<b>Subject</b>	<b>DPIE Model Review</b>	<b>Project Name</b>	Bowdens Silver Project
<b>Attention</b>	Paul Ryall	<b>Project No.</b>	IA132500
<b>From</b>	Greg Sheppard		
<b>Date</b>	2 June 2021		
<b>Copies to</b>	Nick Warren

**Figure 1 Steady State Model Calibration – Modelled vs Observed Heads (m AHD) (all model targets) (Figure 21 Annexure 9 of Updated Groundwater Assessment)**

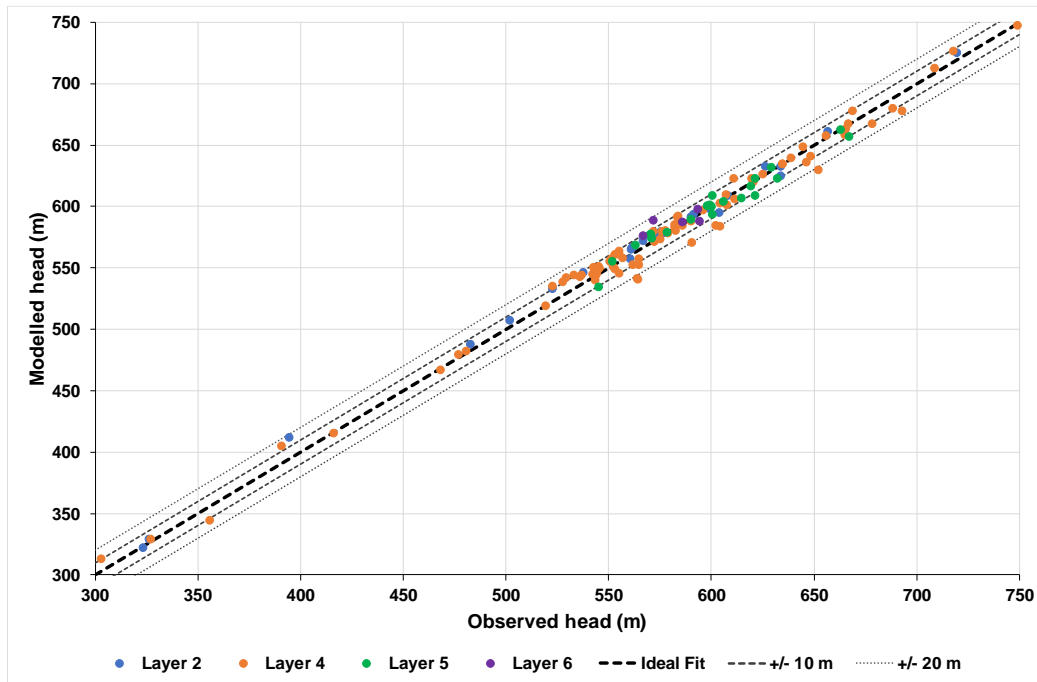
***Scattergram 'ideal fit' line is misaligned (formatting issue, not performance).***

- The calibration scattergrams have been updated with a corrected "ideal fit" line. These are presented in Section 4 of Annexure 9 of the Updated Groundwater Assessment and reproduced below.
